6 SUBMISSION RESPONSES – VOLUME D

6.1 D3 – Airspace Architecture (32 of 196 submissions)

Draft EIS/MDP reference: Chapter D3 – Airspace Architecture

Figure 3.6d Current and proposed (Option 2A) STARs on Runway 01R and 01L

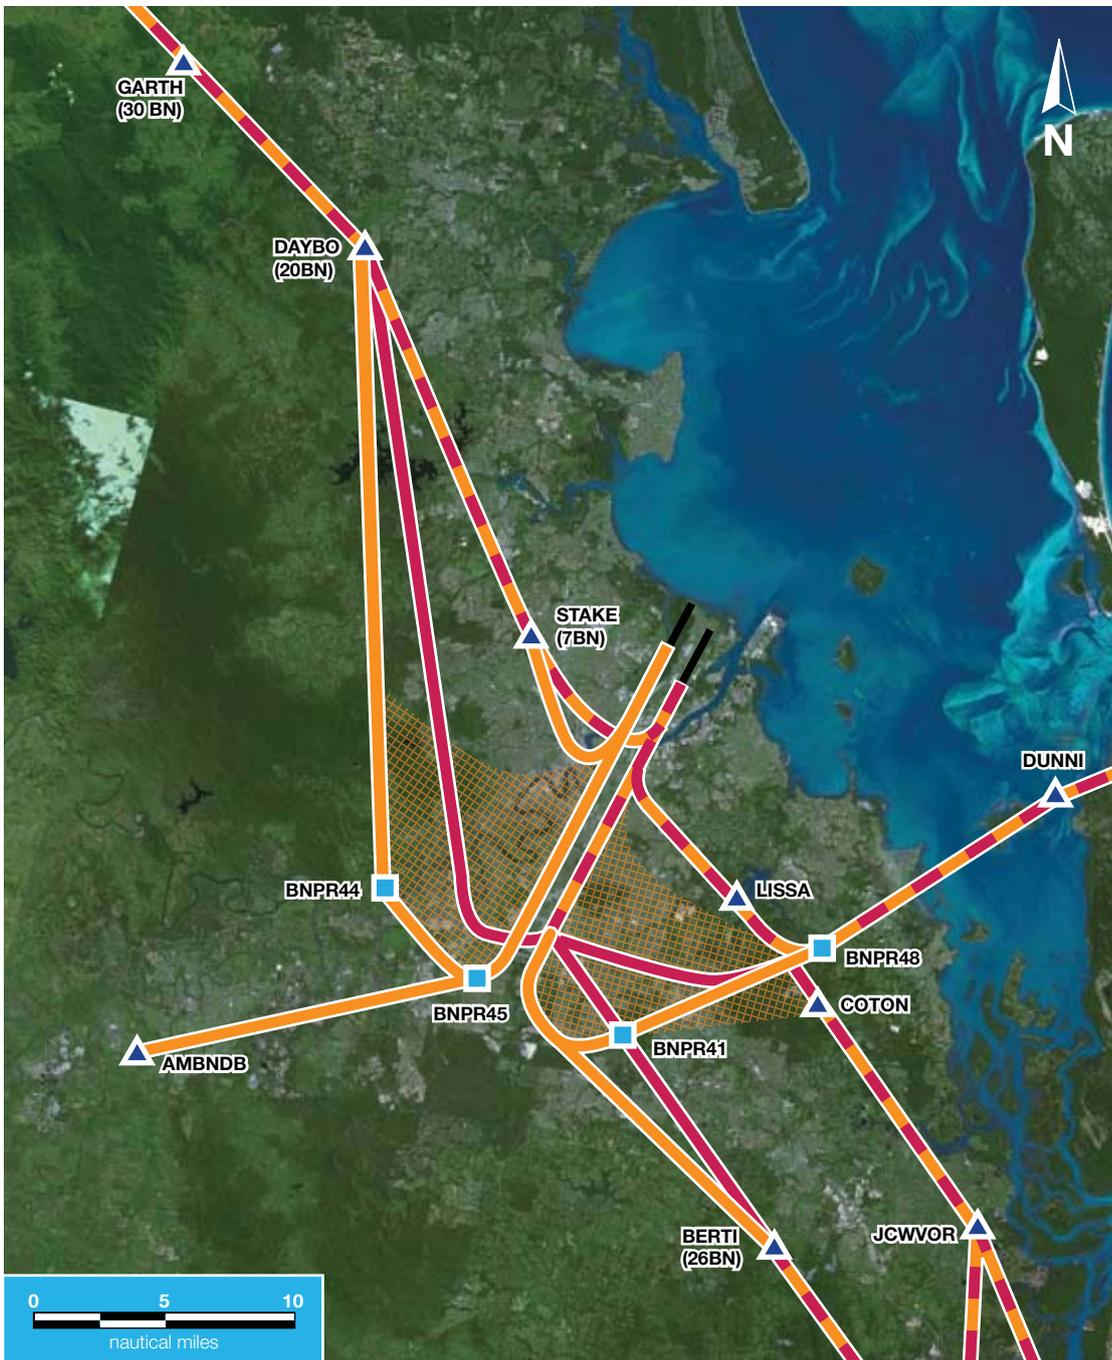
- i) the alternate use of flight paths to provide respite;
 - ii) a system for the continual flight path improvement with implementation of new navigation technology that minimises aircraft noise as soon as possible;

- iii) spreading movements over the flight path zones with radar vectoring and less use of waypoints;
- Flight paths should be designed so aircraft fly over the bay (e.g. “90% should fly over bay now”) or use uninhabited corridors (e.g. Gateway Motorway corridor) (12/32);

The NPR will provide greater opportunity for noise sharing than is currently available with the radar vectoring of aircraft into the Chevron airspace (discussed in Chapter D3) for the arrivals on Runways 01L&R and departures off Runways 19L&R over Brisbane.

The radar vectoring of aircraft in the future flight path design is shown in Figures 3.6a to 3.6g in Chapter D3. Figure 3.6d is reproduced below as an example. The orange cross hashed area represents the area in which aircraft will be vectored.

However, this STAR will move further south with arrivals on the NPR as shown in Figure 3.6d in Chapter D3 and reproduced earlier in this Section.

Figure 3.6g: Over-bay flight paths

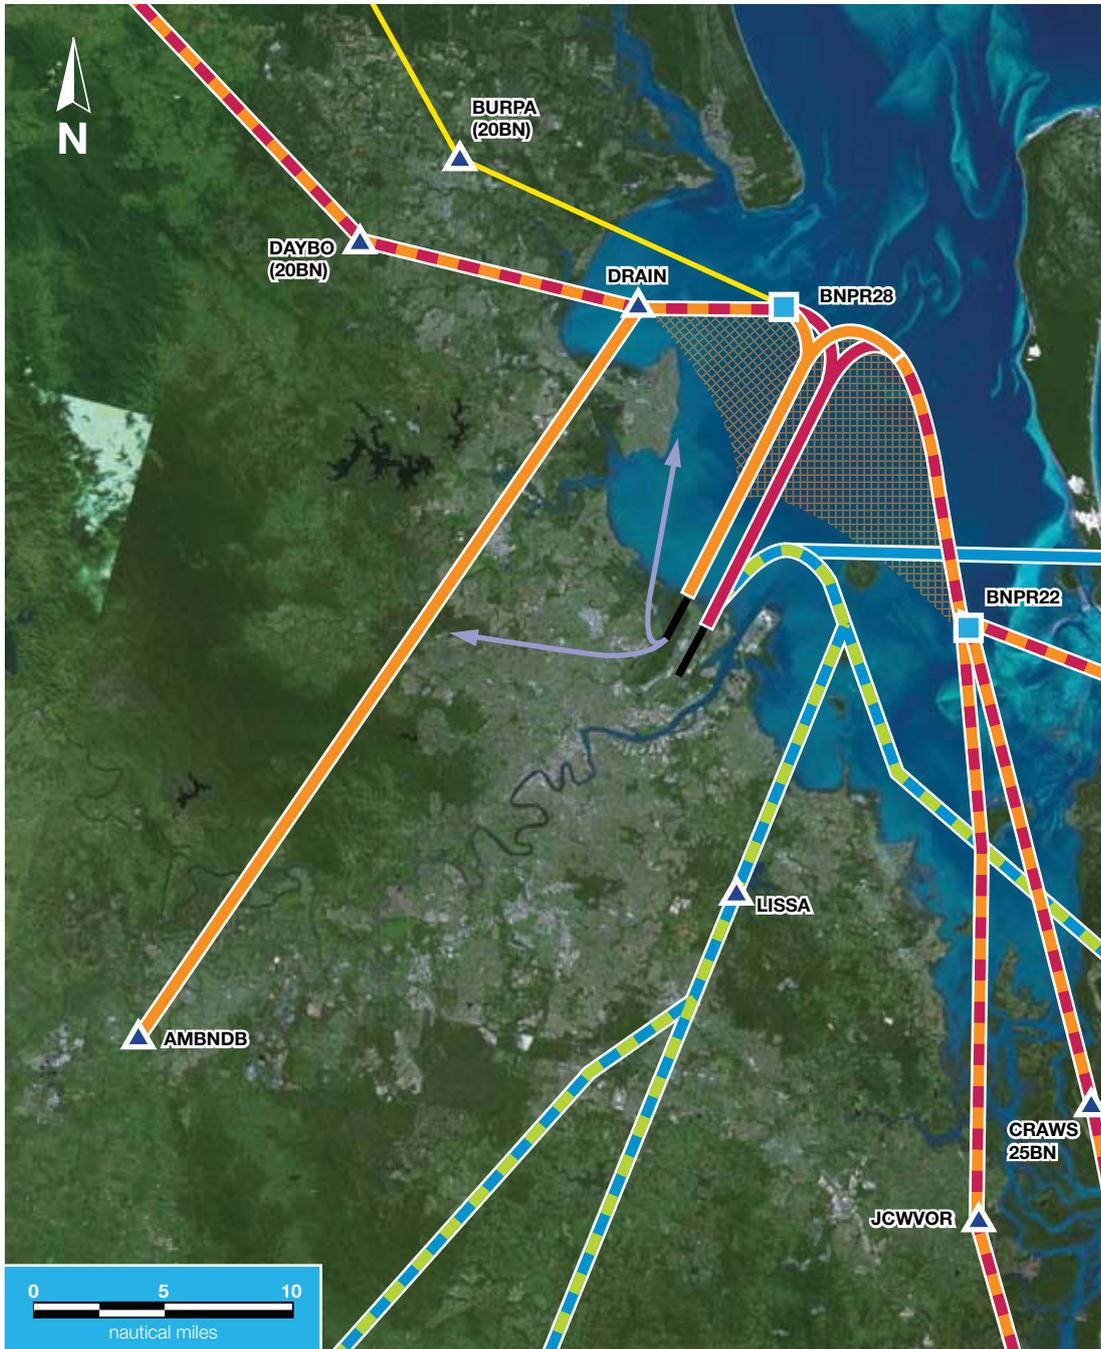
- Why can’t flight paths be over the bay like at night? (2/32);
- Existing flight path over Cleveland and Thornlands has not been acknowledged in Draft EIS/MDP or TNIP and movements on this flight path should be decreased (2/32);

The Draft Parallel Runway Operating Plan has been designed to maximise the number of flights over Moreton Bay. Most movements at night will be over the bay, however, due to weather conditions and traffic volumes, over-bay operations are only available for a small percent of the time during the day and early evening periods. The flight paths for over-bay operations were provided in Figure 3.6g in Chapter D3, which is reproduced below.

The operating requirements for the over-bay modes (SODPROPS, DODPROPS and existing Reciprocal Operations) are discussed in detail in Chapter D10, Section 10.3. Useful background information to assist understanding Airport operations and modes has also been provided in Chapter D2.

Figure 2.2.b: Crosswind and Downwind on Runway 01/19 for a 25 Knot North-Easterly

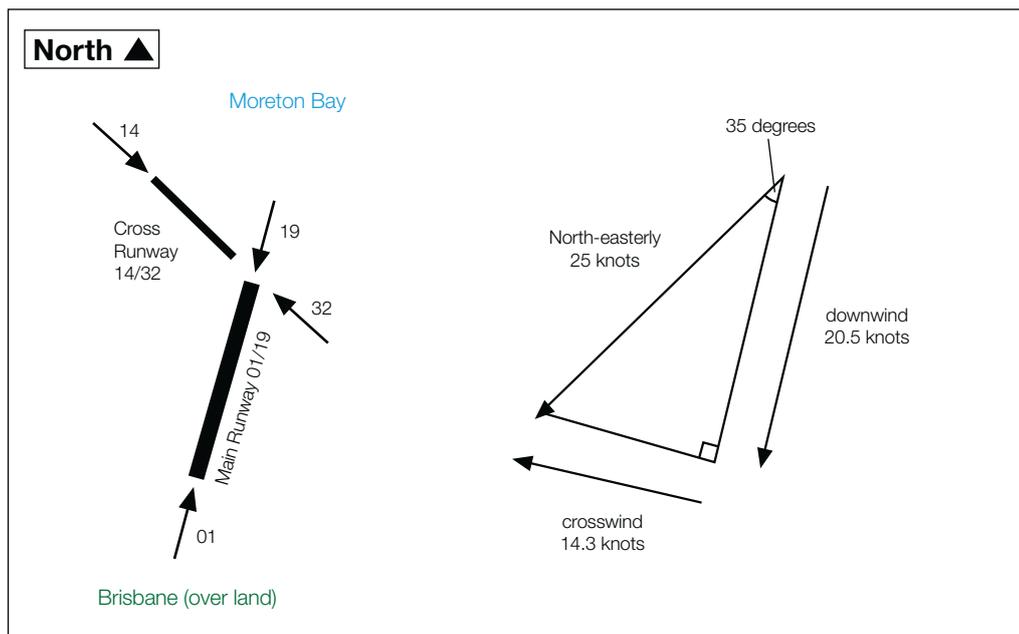
- Disbelief that weather conditions affect the choice of flight paths over Murarrie (Runway 19 departures) and the use of the 01 visual ‘River’ track (2/32);

Wind directions, wind speeds, cloud cover, rainfall and visibility at the Airport determine what the preferred runway and flight paths will be at any time. This is explained in detail in the background information in Chapter D2 in the Draft EIS/MDP. It is also important to note that the wind at the airport is most commonly described in its crosswind and downwind component. Figure 2.2b from the Draft EIS/MDP is reproduced below for information.

The crosswind is the vector component of wind that blows perpendicular to the runway and the downwind component is the vector component of wind that blows in line with the runway. This is important, as it is the downwind component that determines which runway is used. If the downwind is less than 5 knots, then ATC can choose either runway. Runway 01 is currently the preferred default on the basis that arriving aircraft are typically less noisy than departing aircraft, however, the choice will depend on air traffic conditions at the time as switching runways requires a rearrangement of impending arrivals. For example, if the airport is operating with Runway 19 and downwind drops below 5 knots, ATC will elect to stay with Runway 19 rather than switch to Runway 01, especially at busy times, in order to maintain operating efficiency or if the winds are forecast to pick up again.

It is important to note also that the wind speed and/or direction can vary across Brisbane compared with the Airport, such that there are times where winds may appear calm to light at a suburb in Brisbane away from the coast, but at the airport, the winds can be quite strong and even from a different direction. This can often be the case in summer with the localised coastal effects of a sea-breeze.

Figure 1: Track Plot: coloured by height for jet arrivals for the period 2/12/2006 to 8/12/2006

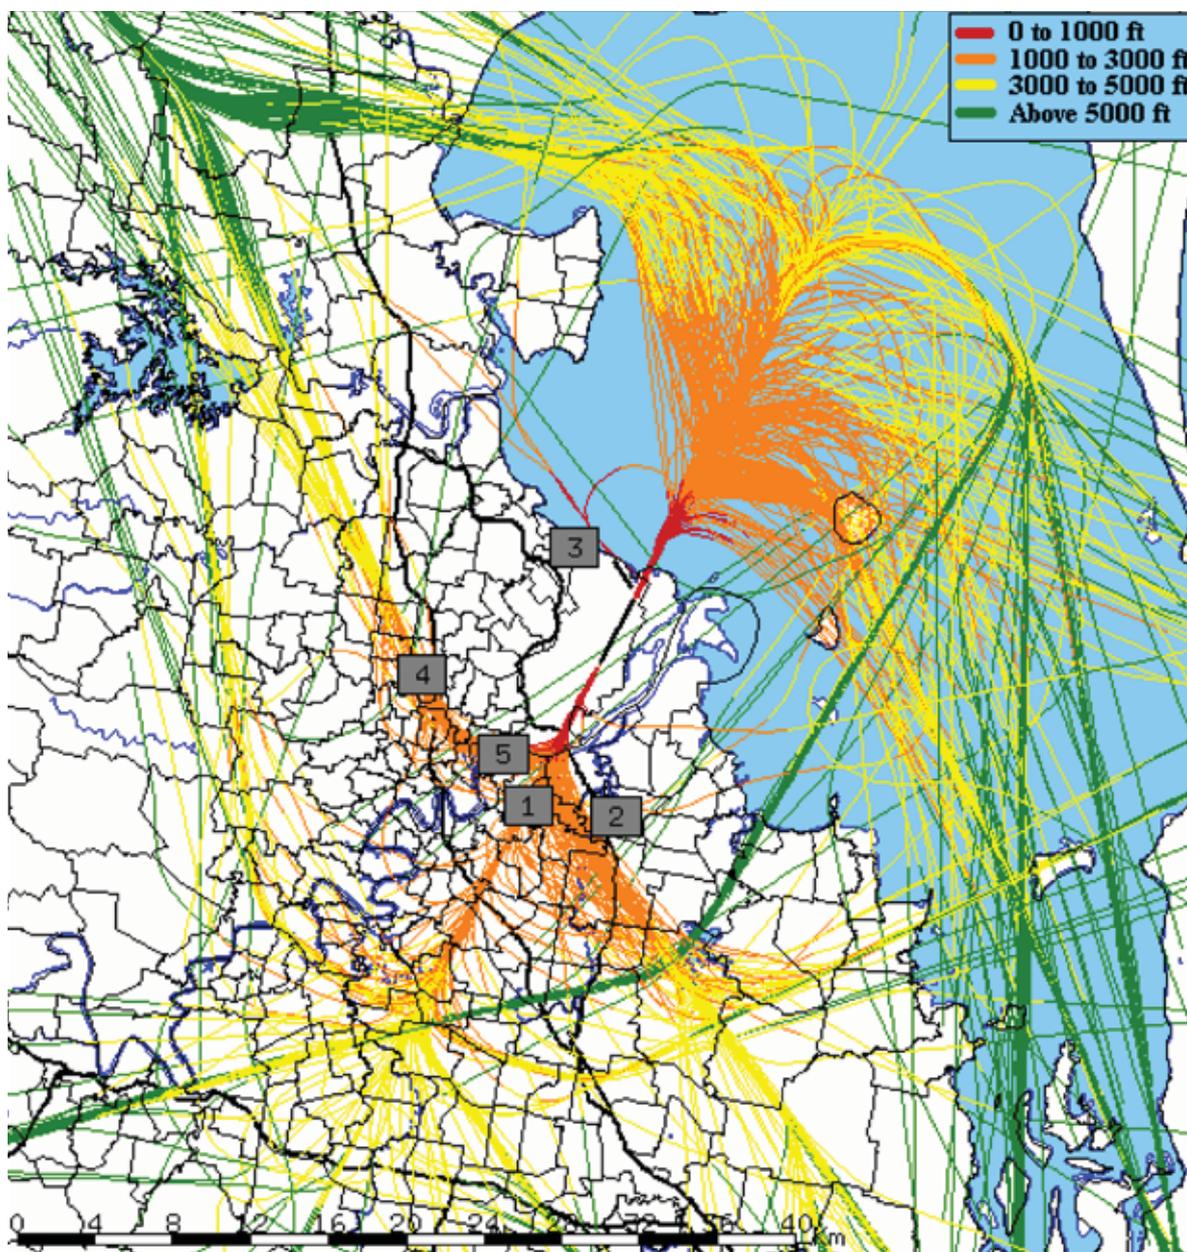
- Flight paths over Moreton Bay and ocean do not consider impacts on Stradbroke Island;

The flight paths over Stradbroke Island have not been shown in the TNIP model or the Draft EIS/MDP or in the Noise and Flight Path Monitoring System (NFPMS) quarterly reports produced by Airservices Australia as it is beyond the extent of the study area considered to be impacted by aircraft noise. An example figure from the NFPMS last quarter report for 2006 showing the flight tracks for a week in December is reproduced in Figure 1 below

Aircraft that fly over Stradbroke Island are on the same standard arrival route (STAR) flight path that passes over Cleveland as discussed in the previous point and shown in Figure 1 below. The STAR passes between the townships of Dunwich or Point Lookout and the occasional aircraft may fly directly over these townships. However, the predicted noise level for the majority of arriving aircraft is typically less than 55 dBA when over Stradbroke Island, with the exception of the large aircraft (eg: 747-400), which are between 55 dBA and 60 dBA.

Figure 2: A 747-400 departure on flight path D in FPNIB

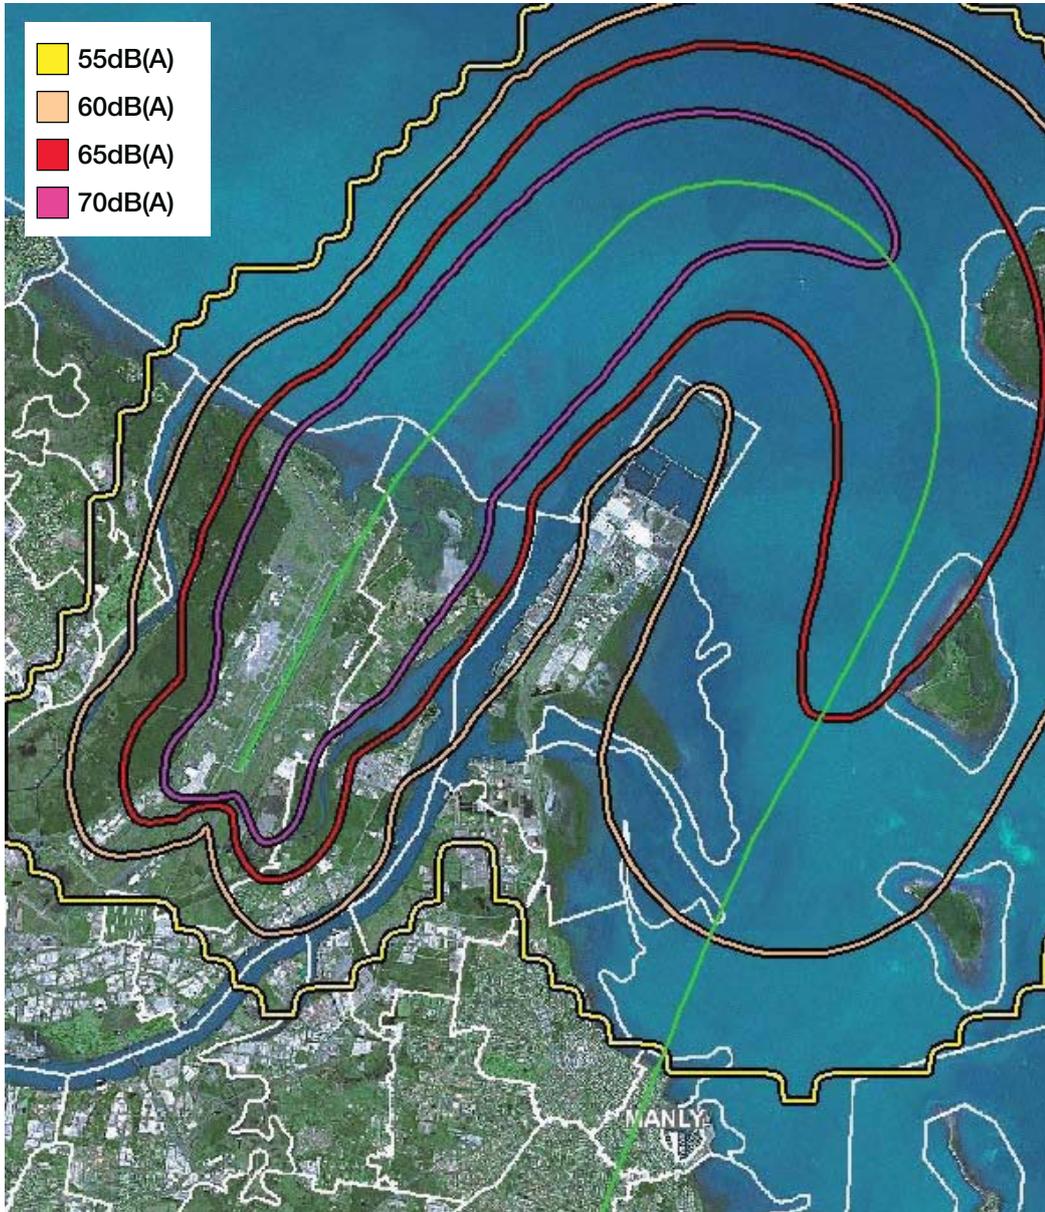
One submission requested aircraft on flight path D in Flight Path and Noise Information Booklet should turn later so that they fly higher over Manly.

In response, aircraft that depart on Runway 01 on Flight path D will have reached an altitude of more than 5000 feet by the time they cross the coast at Manly with a noise level less than 55 dBA. As an example, a single event noise contour from TNIP for a Boeing 747-400 departure (one of the largest and noisiest aircraft to use this flight path) is shown in Figure 2.

Figure 1: Example of single event contour from TNIP of a 737-800 showing the 60, 65, 70, 75, 80, 85 dBA contours

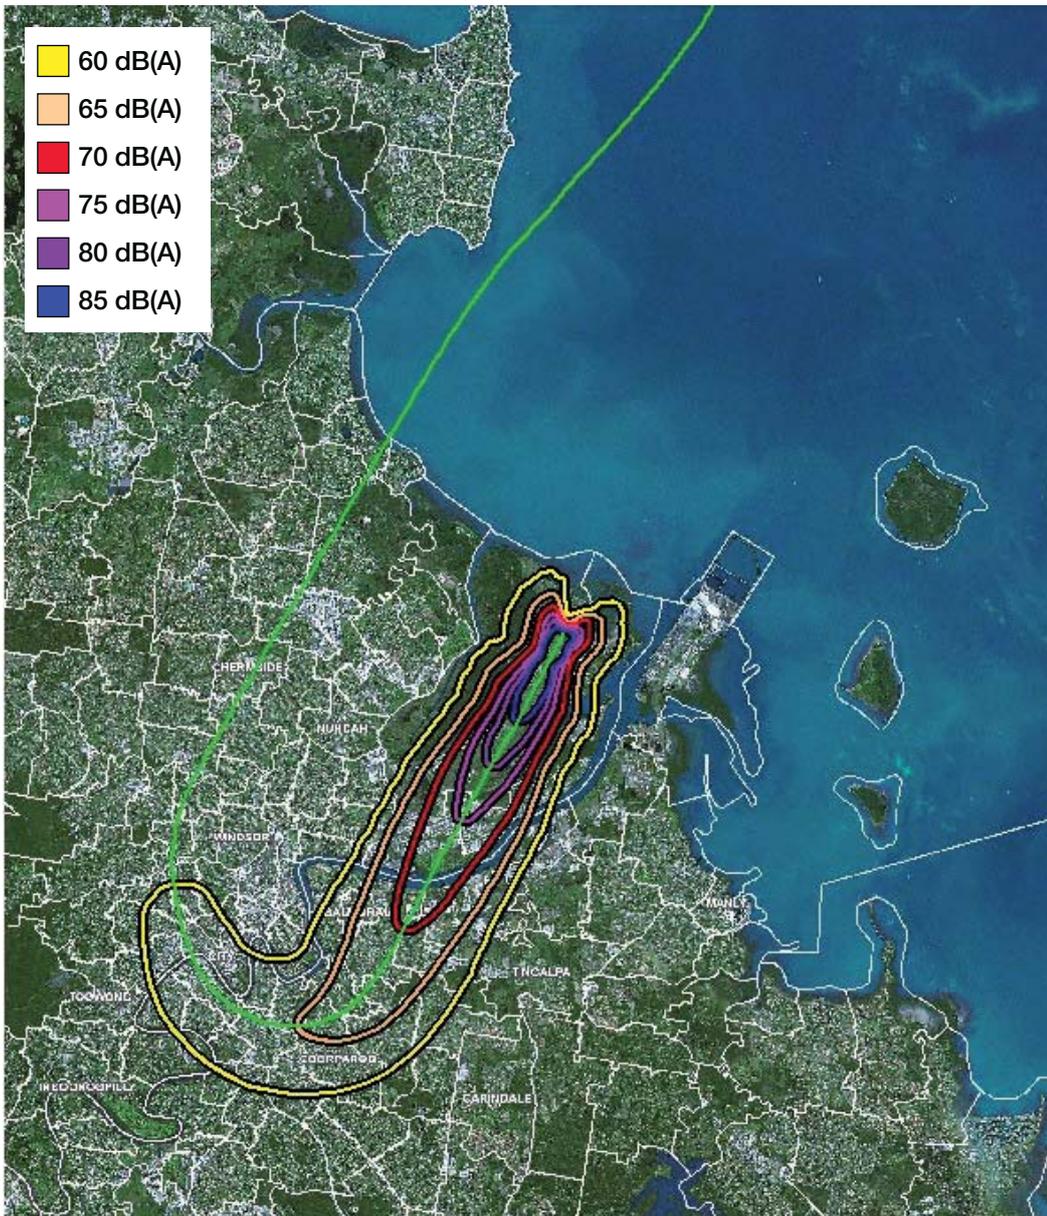
BCC further commented that the N70 noise metric was insufficient to show what was happening above or below the 70 decibel level. Decibel levels above and below 70 decibels were provided in the package of information released on the Transparent Noise Information Package (TNIP) disc.

TNIP is a state-of-the-art model providing actual and modelled information on aircraft movements and associated noise. The N70 is just one of the descriptors used in TNIP. Additional information on other noise levels from 50 dBA to 100 dBA in increments of 1 dBA or more (including 60, 65, 75, 80, 85 or 90 dBA levels) can be obtained through TNIP through the “single event contour” option for each aircraft type and on each flight track. This option allows the user to drill down to determine specific noise levels of individual aircraft overflights that their premises may experience. Figure 1 opposite provides an example of this.

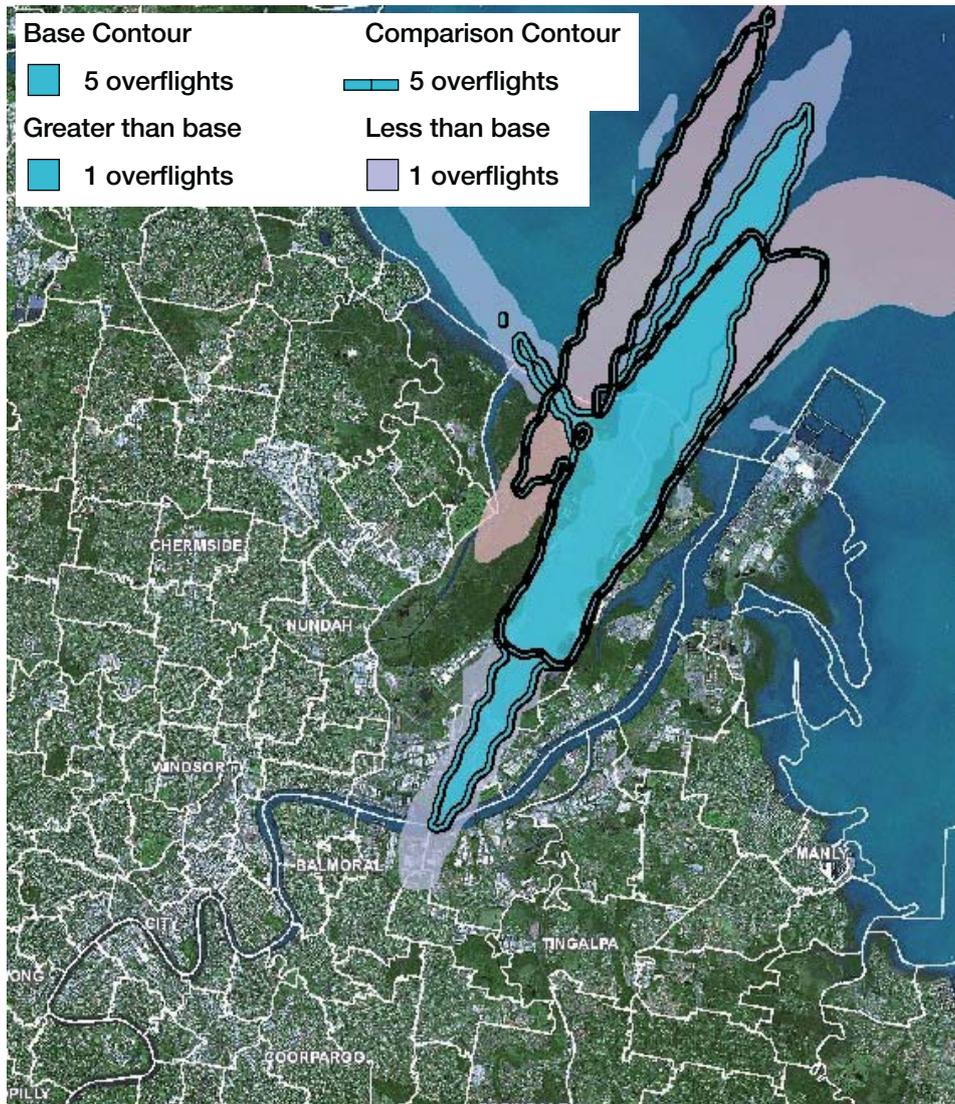
One submitter commented that the analysis presented for Summer as the example did not show the impact of noise in the night hours for Winter. Figure 4 shows the comparison of the before and after case in 2015 for Winter nights. It shows that the N70 (5 overflights) contour for when the NPR is operational in 2015 is much smaller than the contour for the Winter nights before the NPR becomes operational. Weather conditions which favour over-bay operations are more prevalent in the Winter months than the Summer months and therefore presenting the Summer case invariably shows the worst case scenario. The Draft EIS/MDP consistently aimed to illustrate the worst case conditions in order to present the effects of the NPR as transparently as possible.

With the NPR in place the night time noise contour (the dashed line above) for a Winter week day is considerably reduced and contained almost wholly on airport land.
